WILLIAMSON COUNTY, TEXAS  
CHANGE ORDER NUMBER: 2

Project: 1805-229  
Roadway: Bagdad Road at CR 278  
CSJ Number: \_\_\_\_\_

**Bagdad Road at CR 278  
Williamson County Project No. 1805-229**

**Change Order No. 2**

**BAGDAD RD AT CR 278  
PLAN & PROFILE  
BAGDAD ROAD  
STA. 549+00 TO  
STA. 556+00**

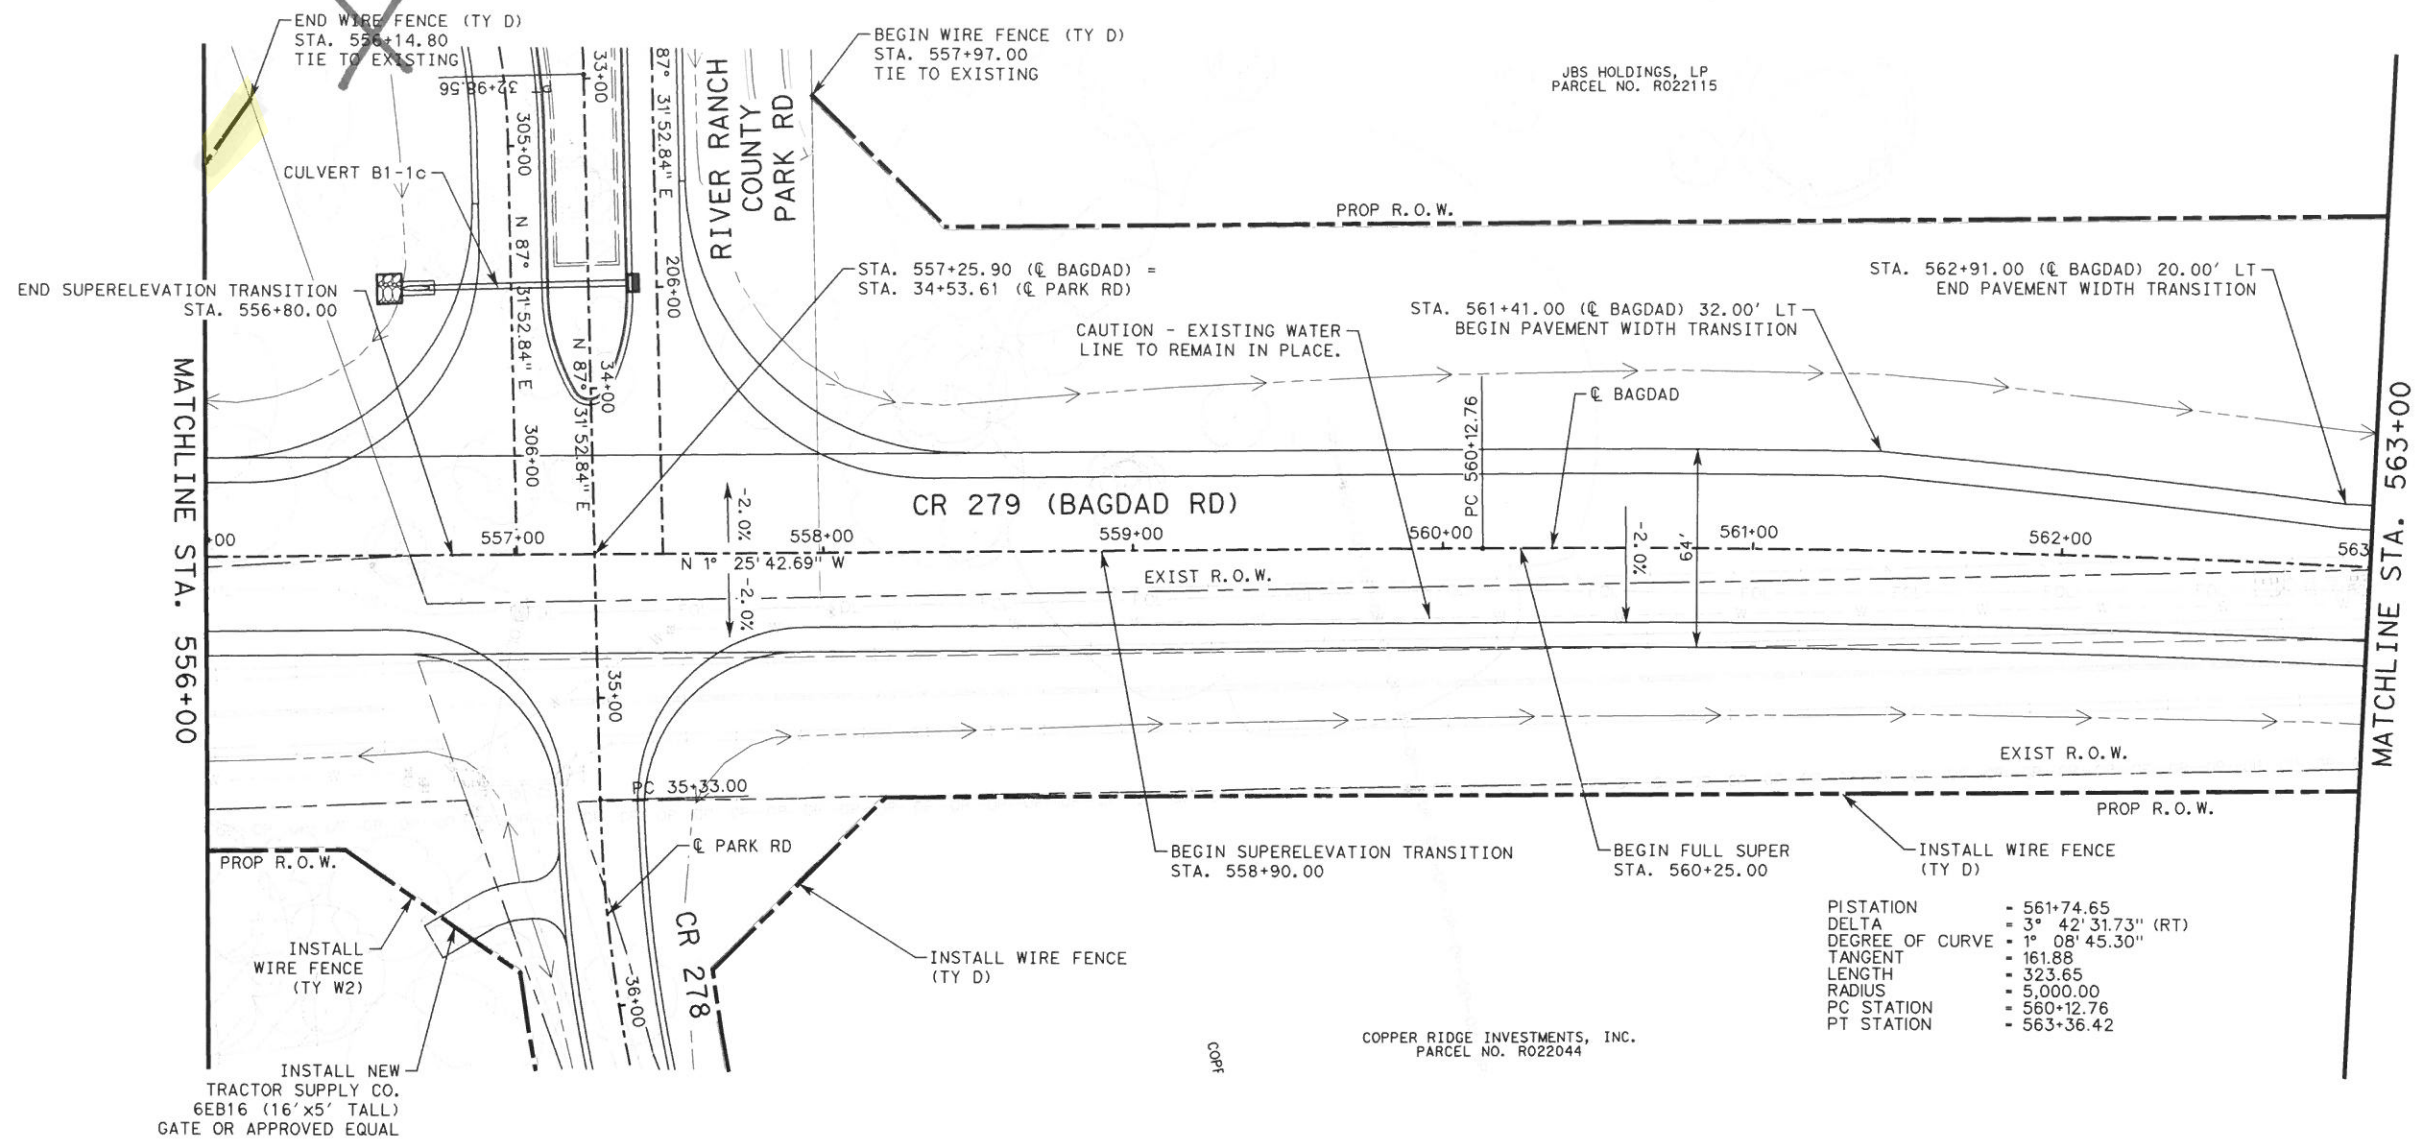
This Change Order also adjusts the quantities of Type D fencing and Type 1 gate as a result of addressing field conditions not accounted for in the original plans. The property between Silver Creek Dr. and River Ranch Park was turned into a subdivision and the proposed wire fence and gate on west side right of way at this location is no longer needed. Also, the driveways at Sta 549+19 and 566+64 have recessed gates and do not require new gates to be installed.
